**GOVERNMENT OF THE DISTRICT OF COLUMBIA  
DEPARTMENT OF TRANSPORTATION**

**MEMORANDUM**

**SUBJECT:** ZC Case No. 16-20 – 3450 Eads Street NE

Figure 1: Site Design and Access (Source: Grove/Slade Associates)

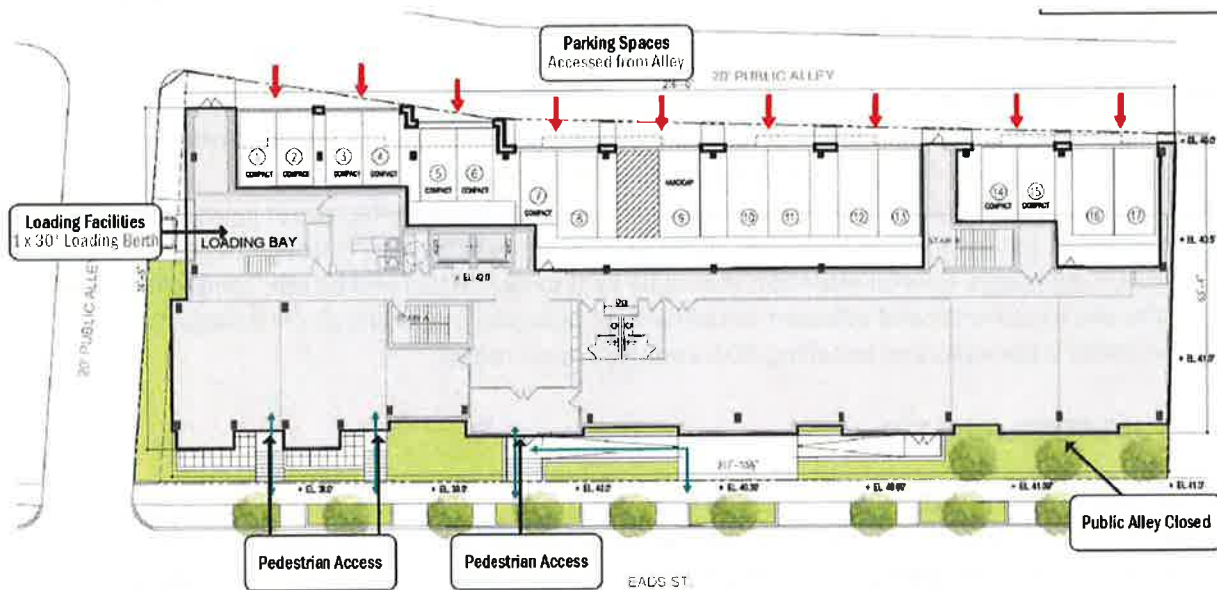
The proposed project is located adjacent to two public alleys to the north and west, Eads Street to the south, and a vacant property to the east. Another north-south public alley bisects a portion of the site, which the Applicant proposes to close. Since the public alleys to the north and west will remain open, DDOT finds the remaining public alley network sufficient for the needs of the square. Vehicular, loading, trash, and long-term bicycle access is proposed from the two public alleys to the north and west of the site. While DDOT does not object at this time to the closure of one of the north-south public alleys, this report does not serve as the approval process for an alley closure; the Applicant must apply through the Surveyor's Order process, which will also require Council approval.
